July 31, 2003
LIC-03-0104

SUBJECT: Fort Calhoun Station Unit No. 1 "Technical Specifications Updated for NRC Comments on Pending Amendment Request on the Pressure-Temperature Limits Report"

**Marked-Up
Technical Specifications
Updated for Pending Amendment
of the
Pressure-Temperature Limits Report**

Figure 2-1

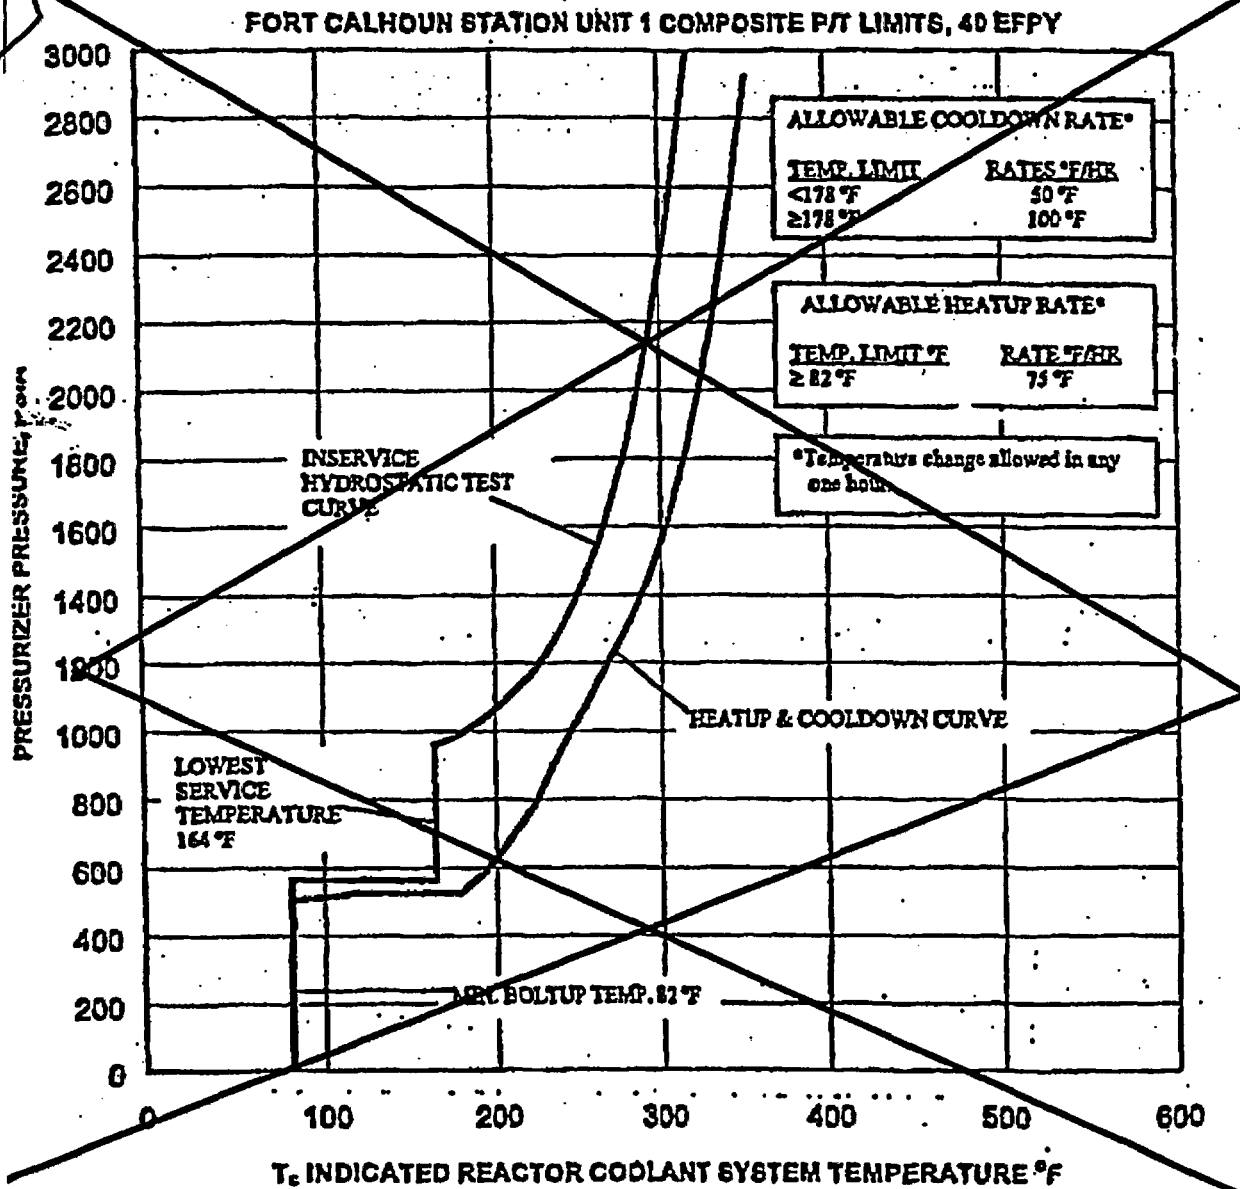
The limit lines in Figures 2-1 are based on Reference 2, Appendix G, W/GE's methodology for P-T limit curve generation¹¹, and ASME Code Case N-640 as discussed below:

The reference stress intensity factor (K_{IR}) used in the development of the limit lines in Figure 2-1 is based on ASME Code Case N-640. This Code case allows the use of K_{IC} (lower bound of static initiation critical stress intensity factor) and is an approved exemption by the NRC in accordance with 10 CFR 50.60(b). K_{IC} is obtained from a reference fracture toughness curve for reactor pressure vessel low alloy steels as defined in Appendix A to Section XI of the ASME Code and is approximated by the following equation:

- 1) Temperature instrumentation uncertainty of 14°F is applied to the entire temperature range of Figure 2-1

- 3) Below 350°F , pressure instrumentation uncertainty is accounted for in the LTOP system setpoints. Above 350°F , a pressure instrumentation uncertainty of 50 psi is applied to Figure 2-1.

The temperature at which the heatup and cooldown rates change in Figure 2-1 reflects the point at which the most limiting heatup and cooldown rates with respect to the inlet temperature (T_i) change.
